ADDENDUM NO. 04

PROJECT: BRADFORD CSD - 2023 CAPITAL IMPROVEMENT PROJECT

DATE: 04/04/2025

2 NEW WORK PLAN
 A201 1/8" = 1'-0"

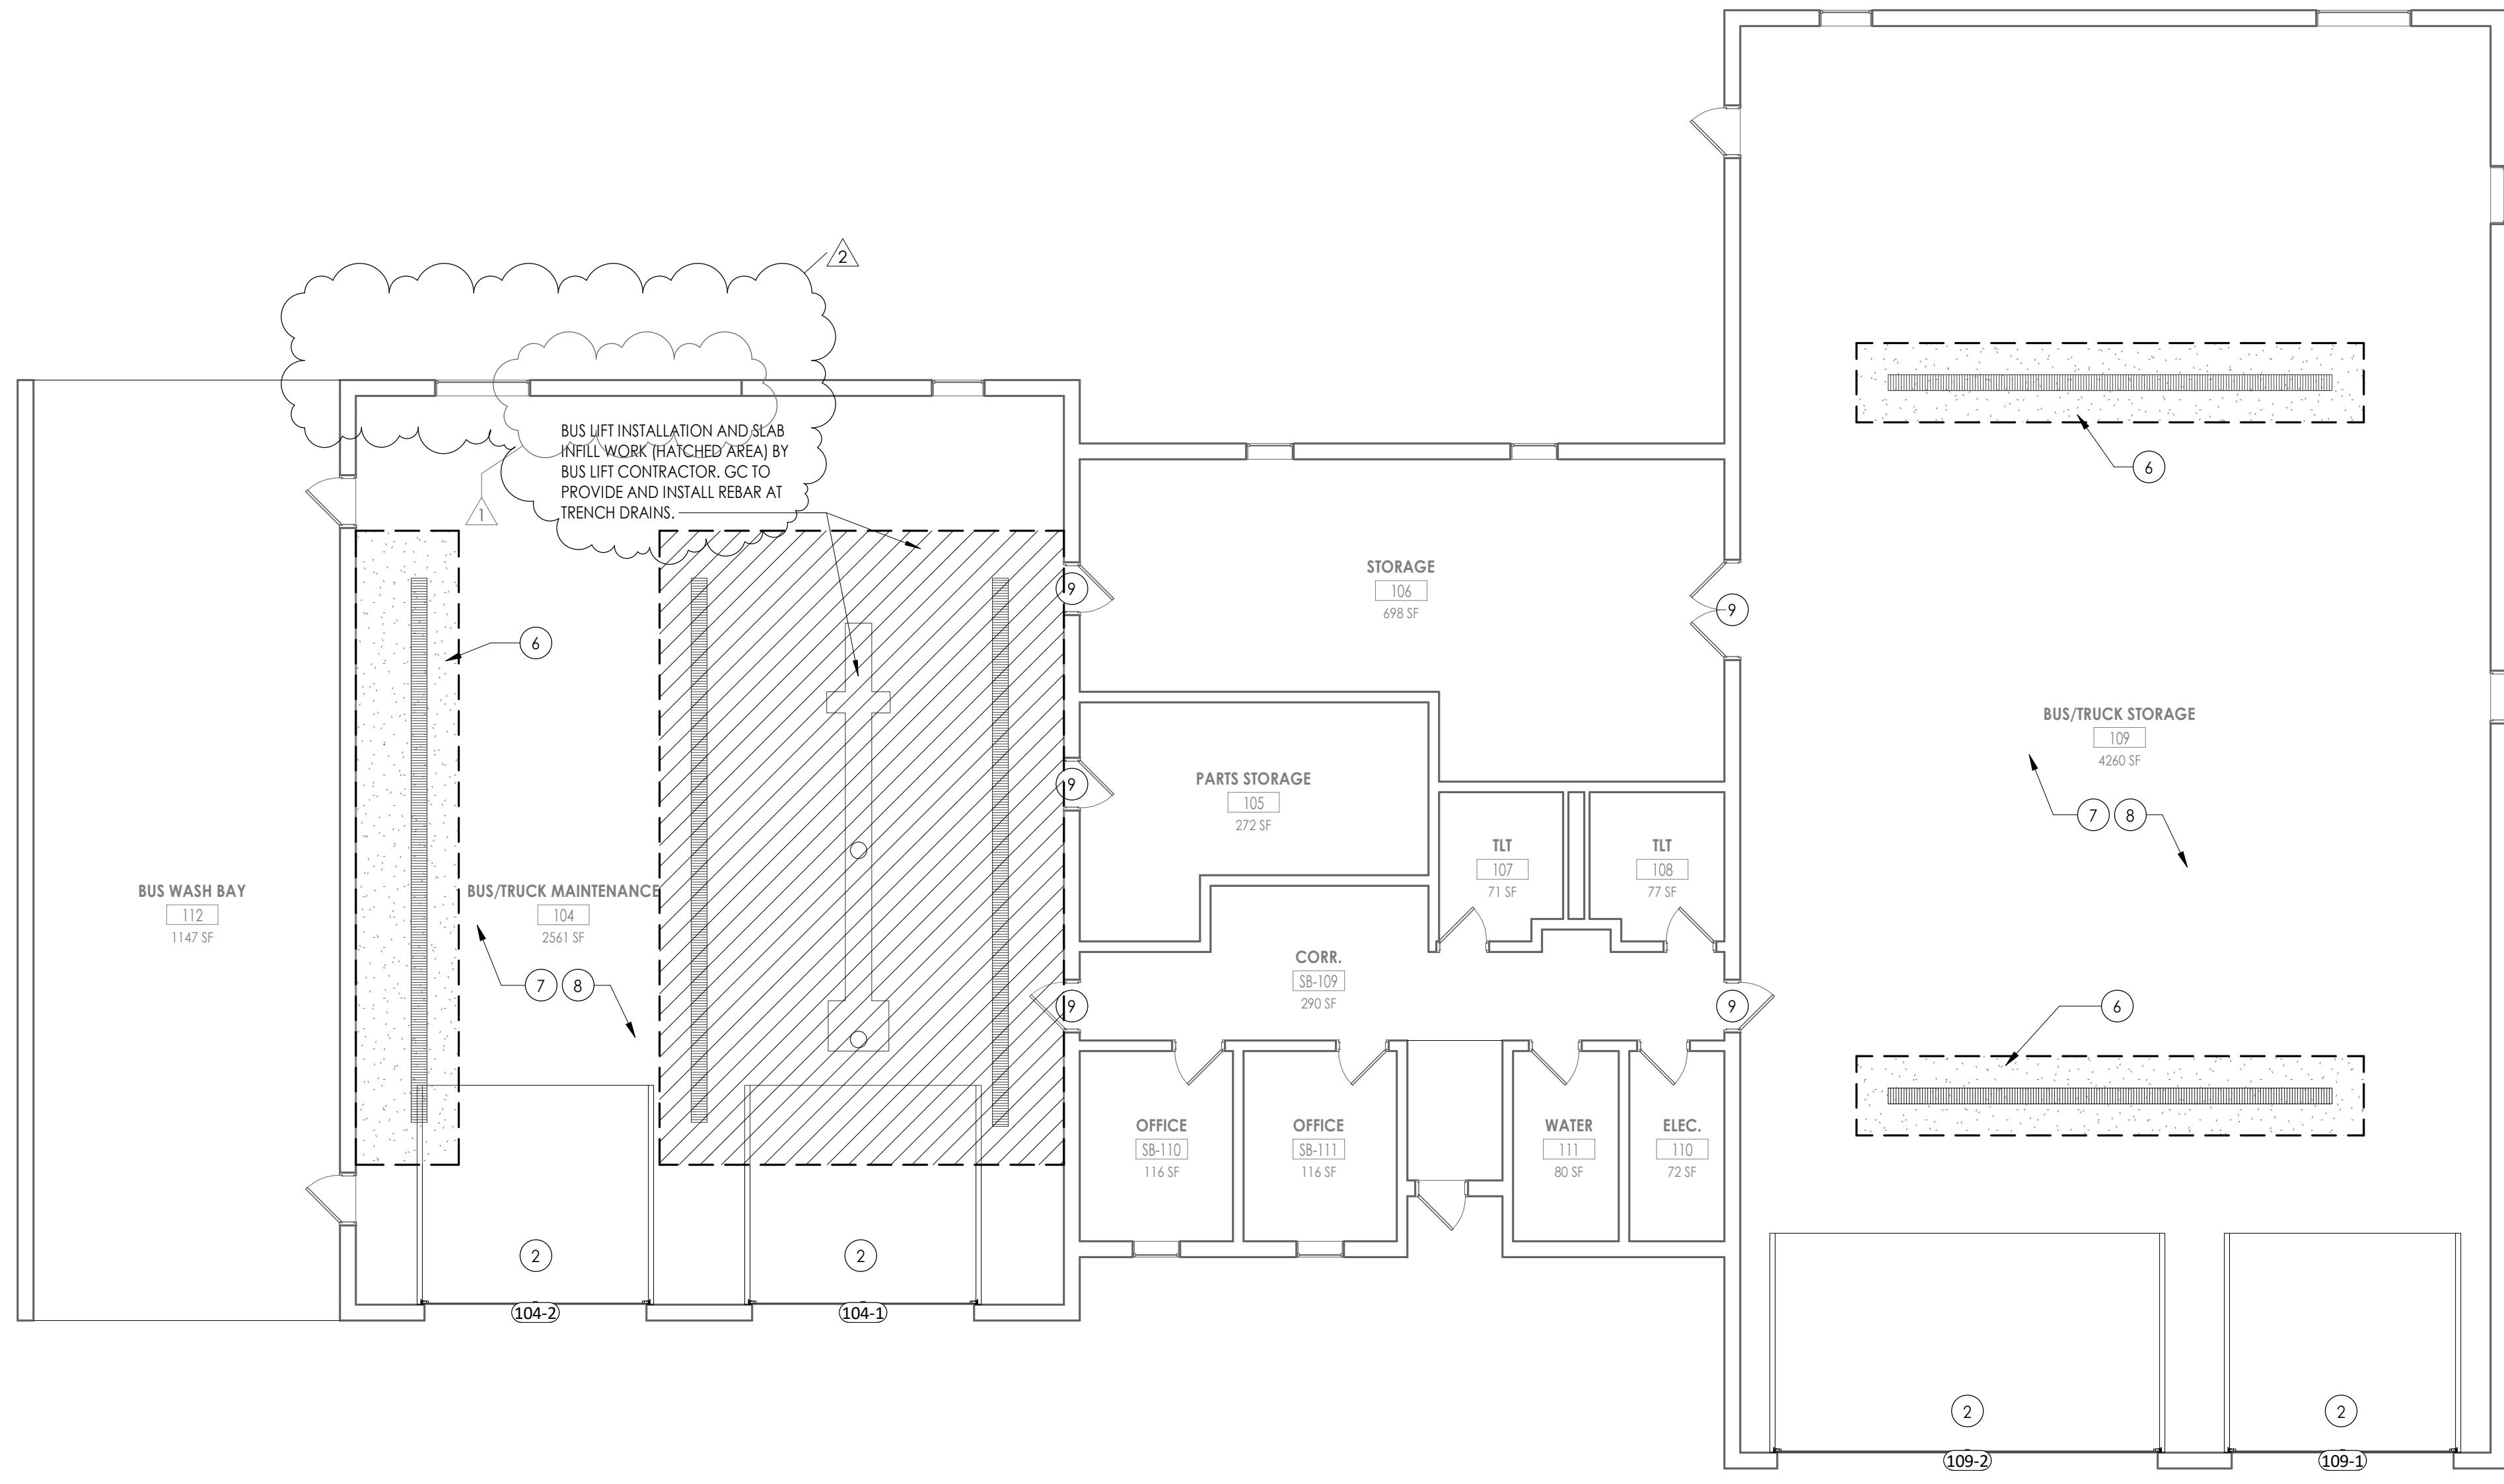
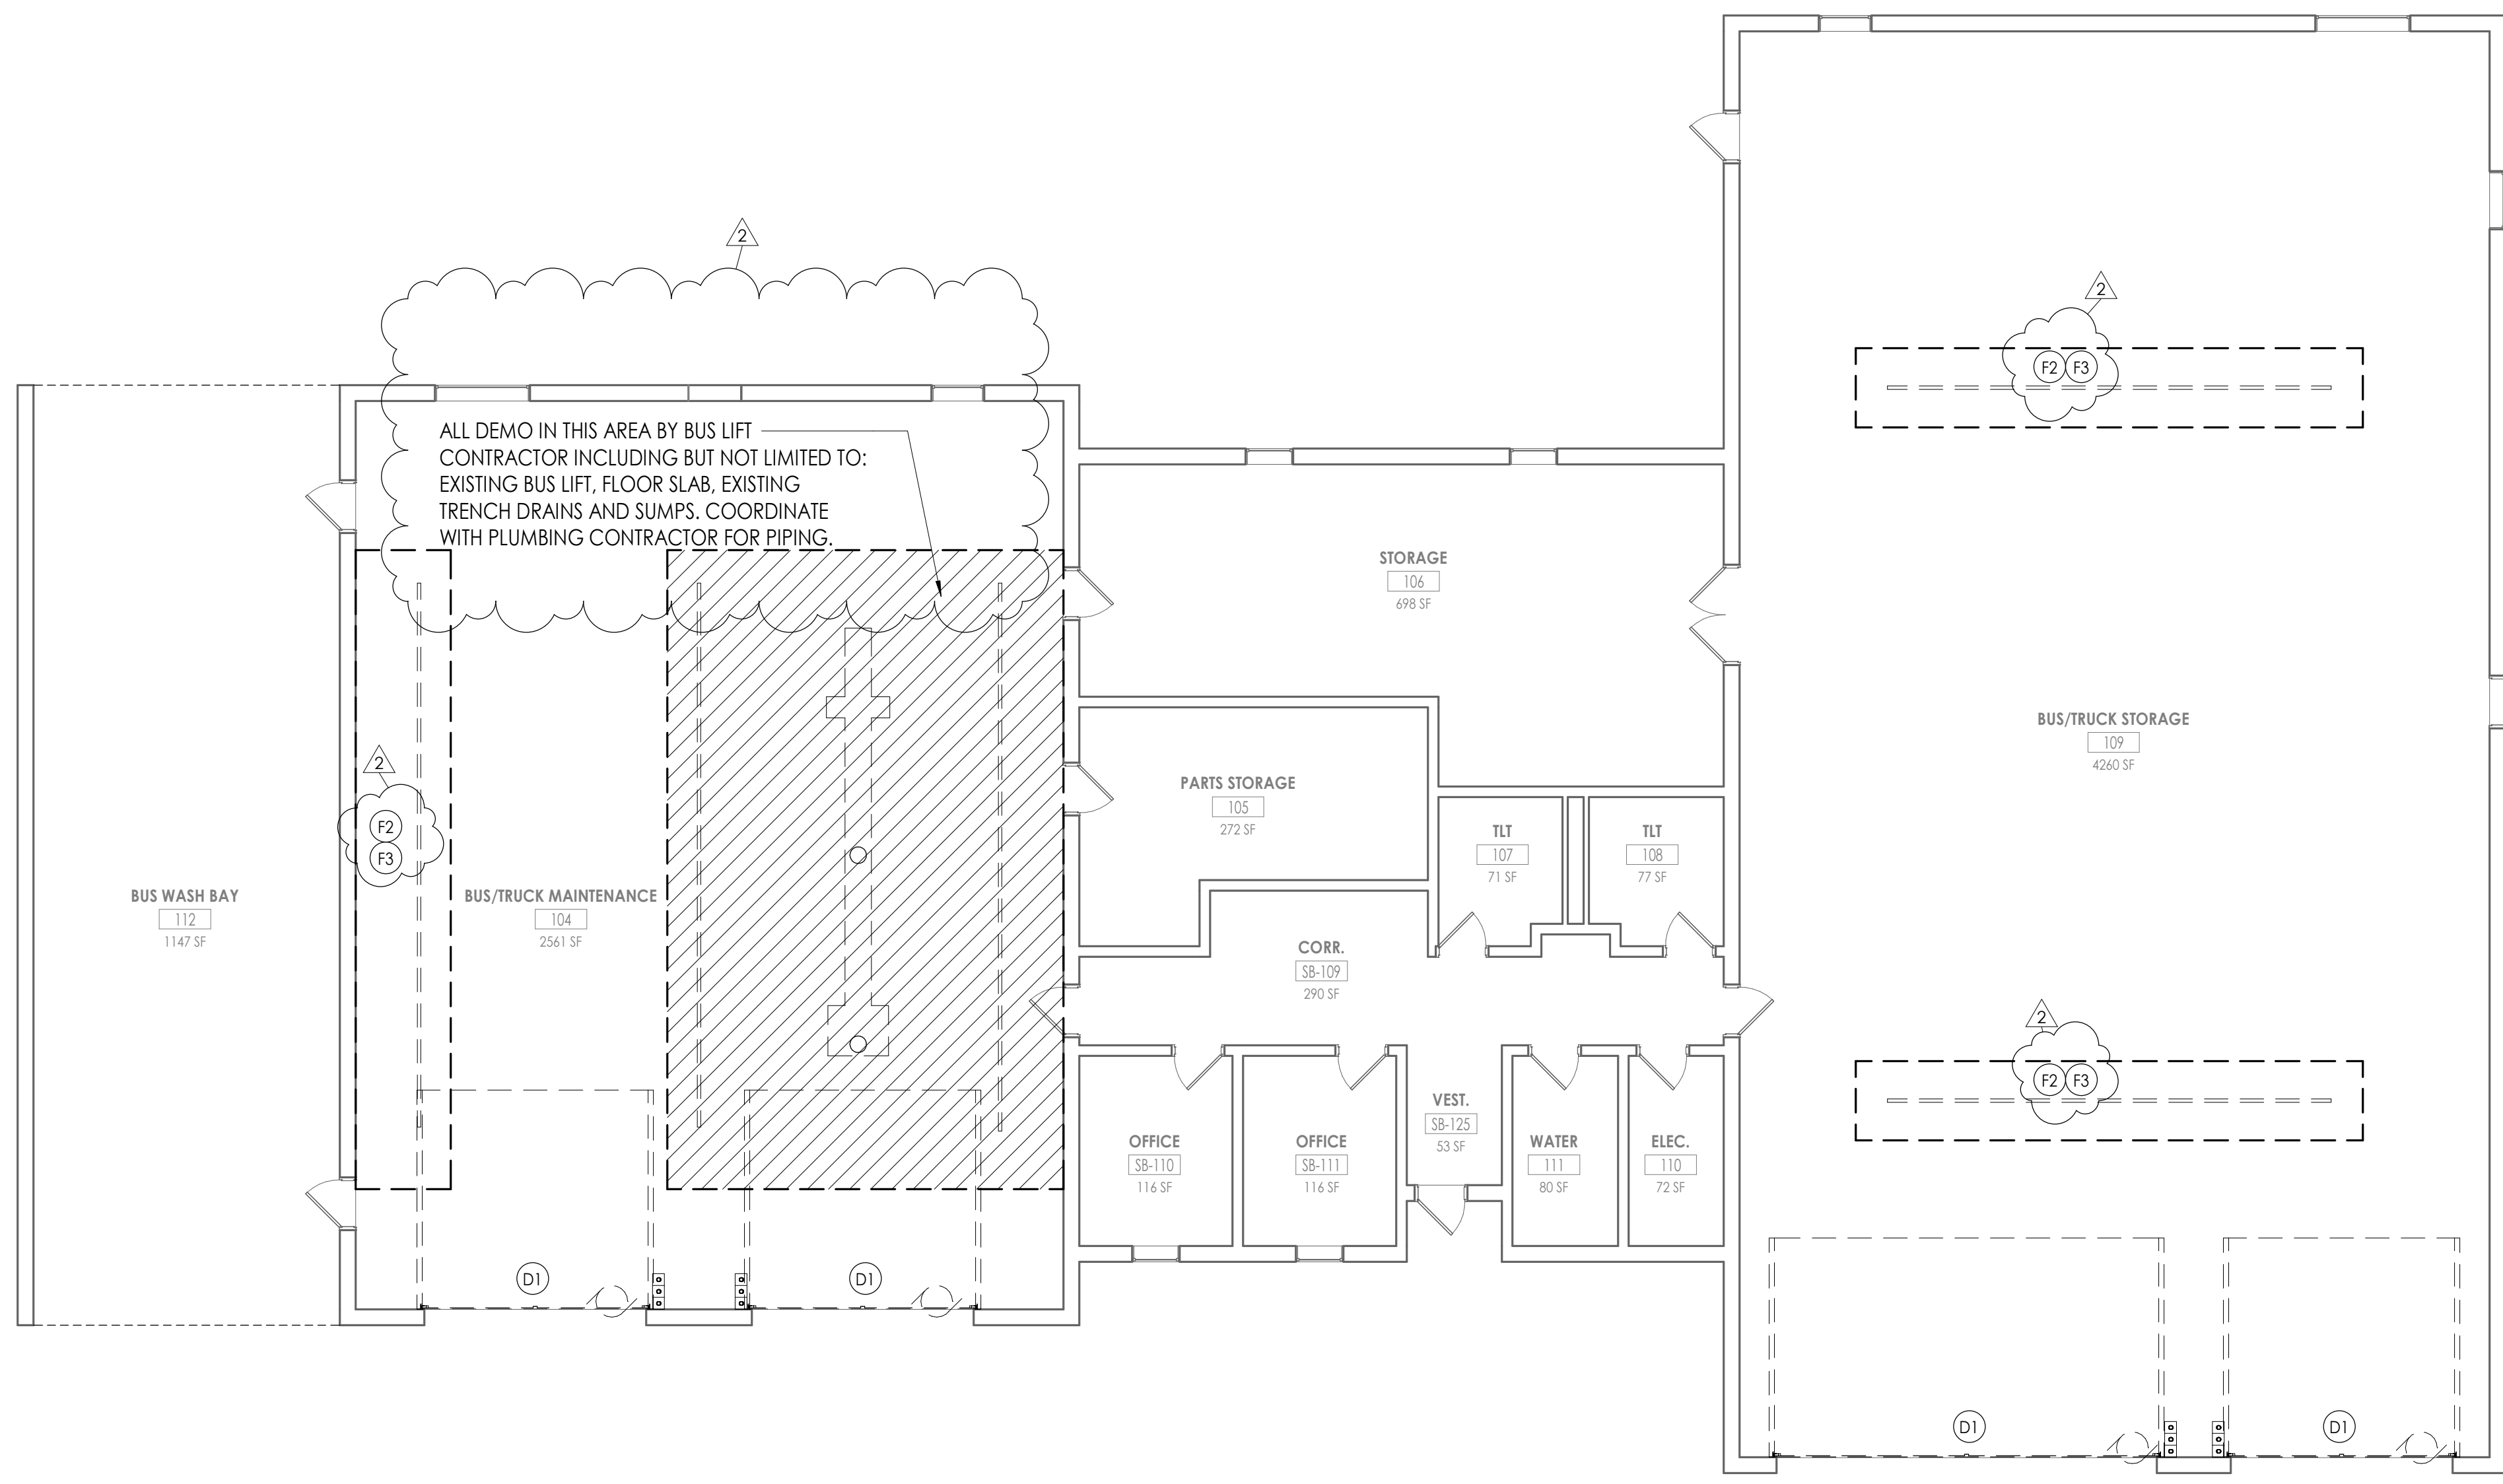
| BG-A201 | REVISE NOTES TO CLARIFY CONTRACTOR SCOPE OF WORK. |

Drawing Number: G C201

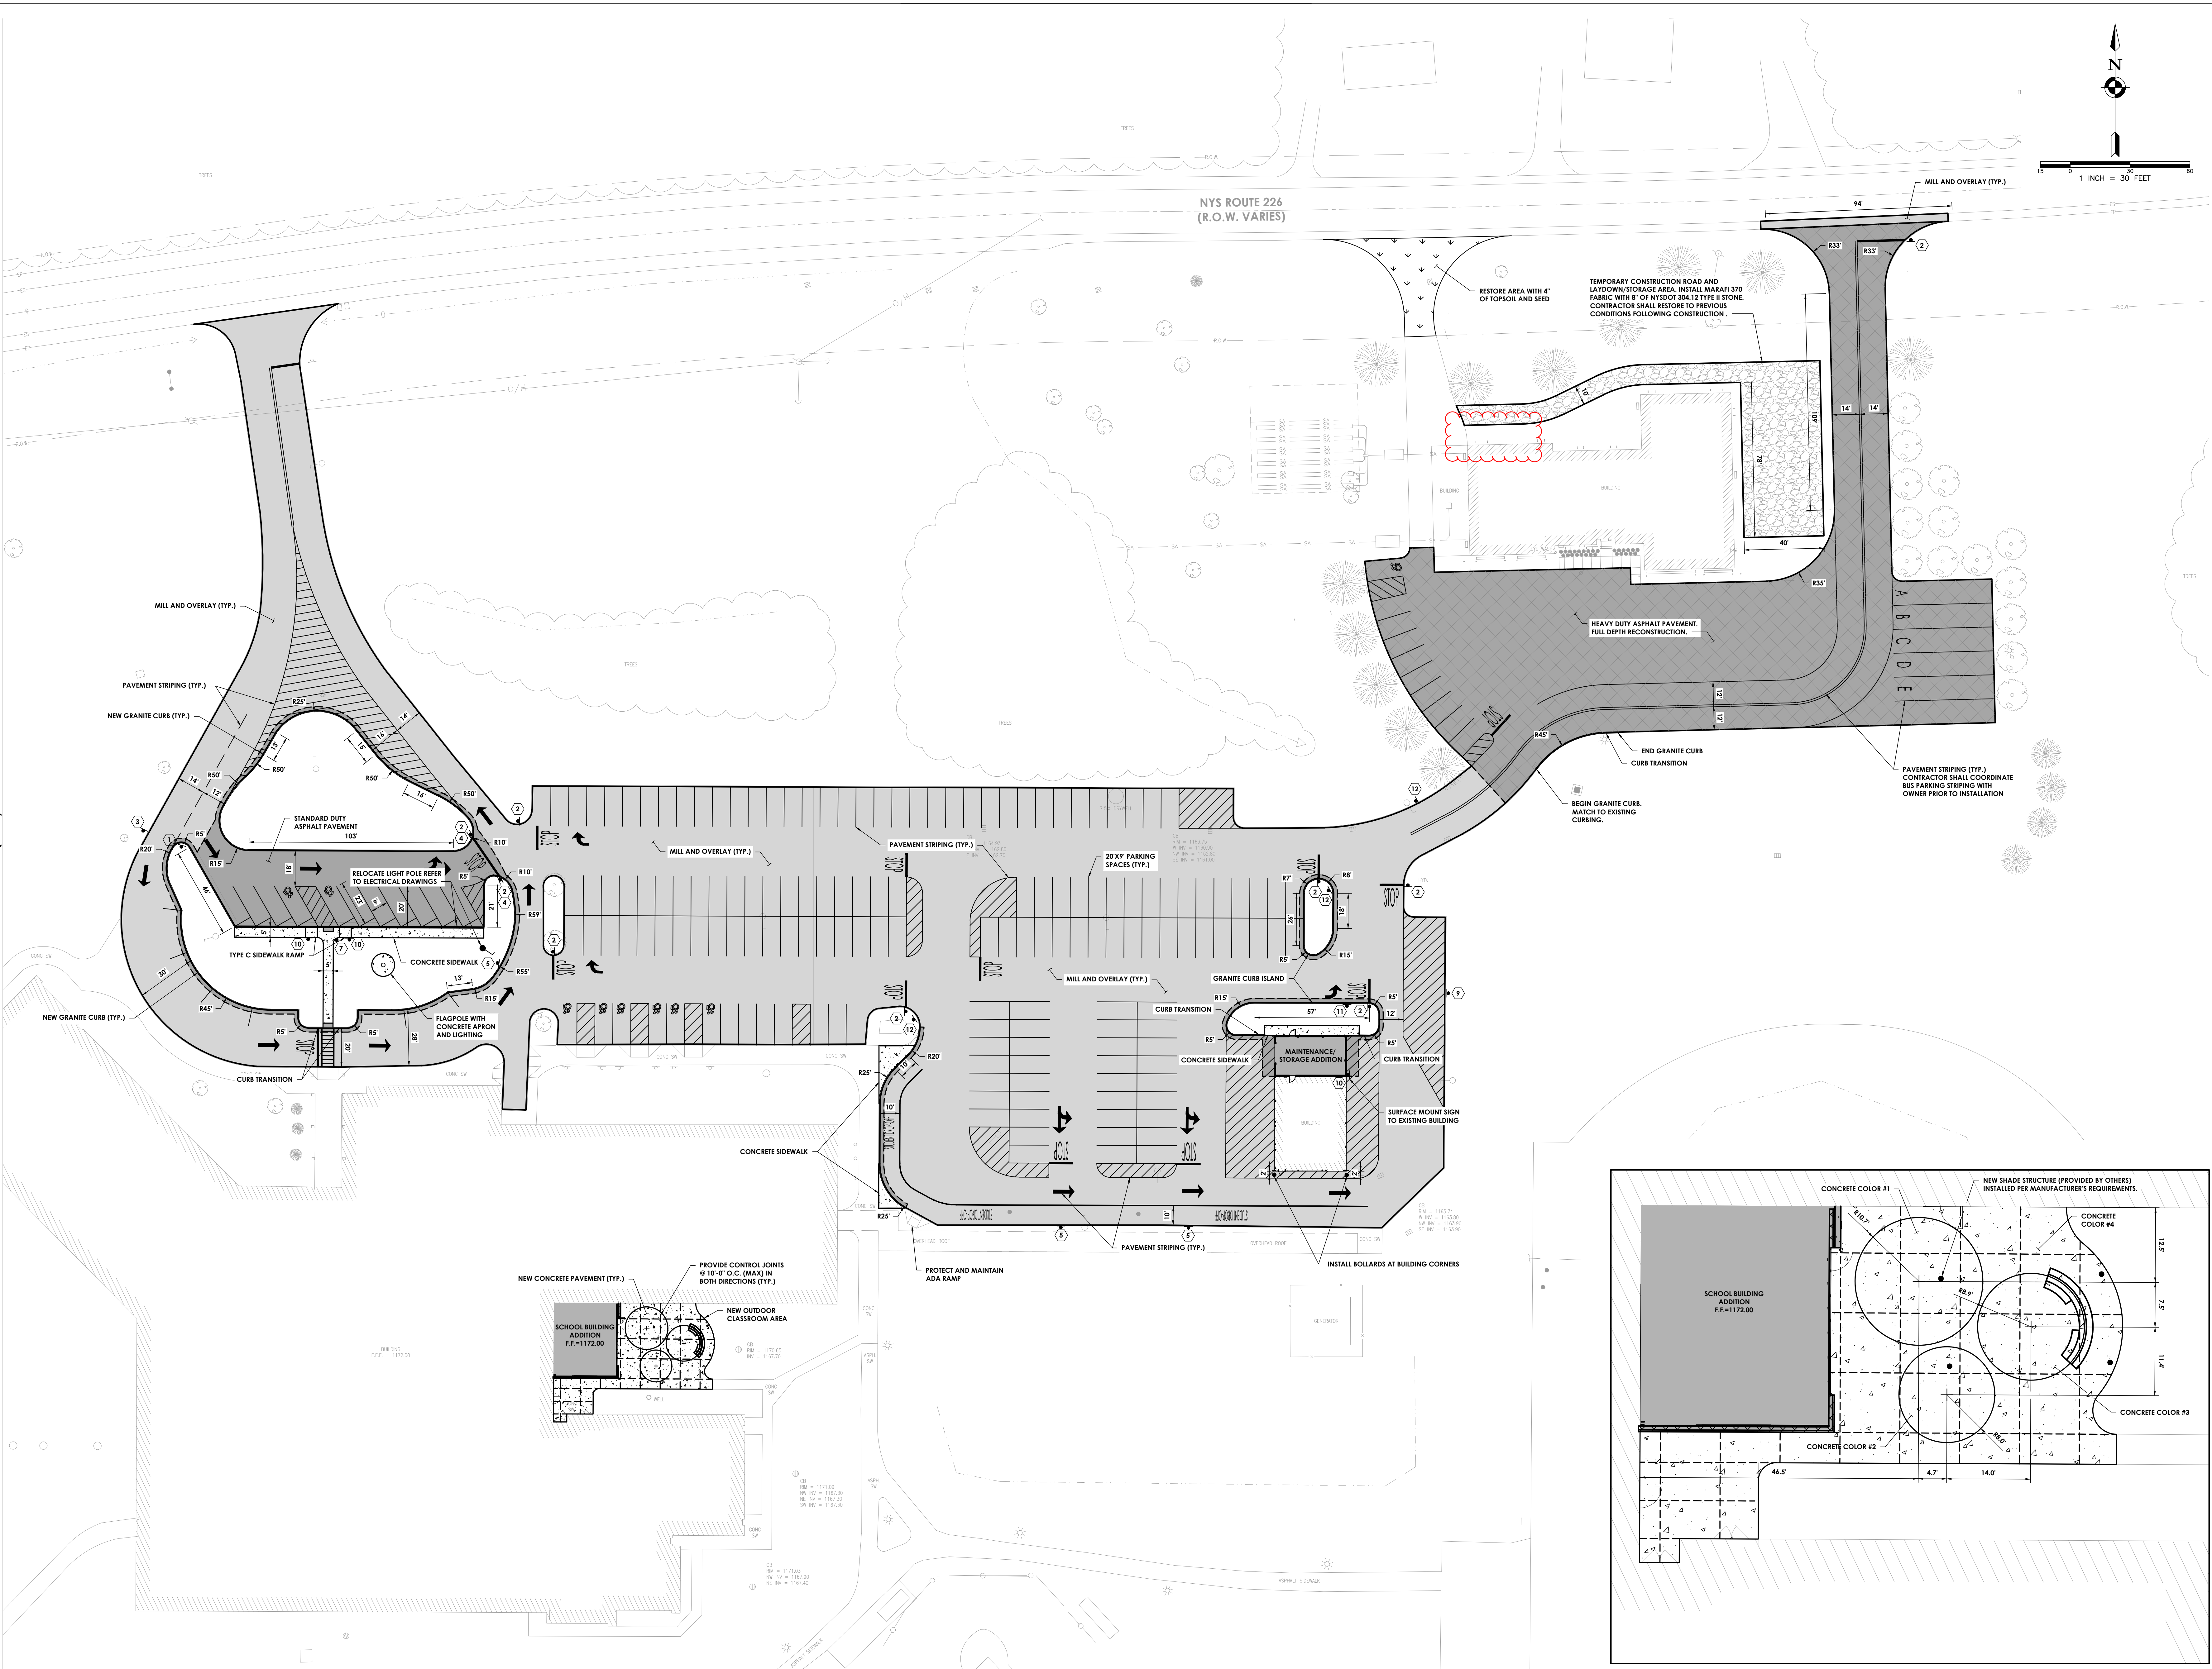
- BG-P800 REMOVED/EDIT COMMENTS TO CLARIFY CONTRACTOR SCOPE OF WORK.
- G – C201 Remove the concrete sidewalk on the northern side of the Bus Garage.
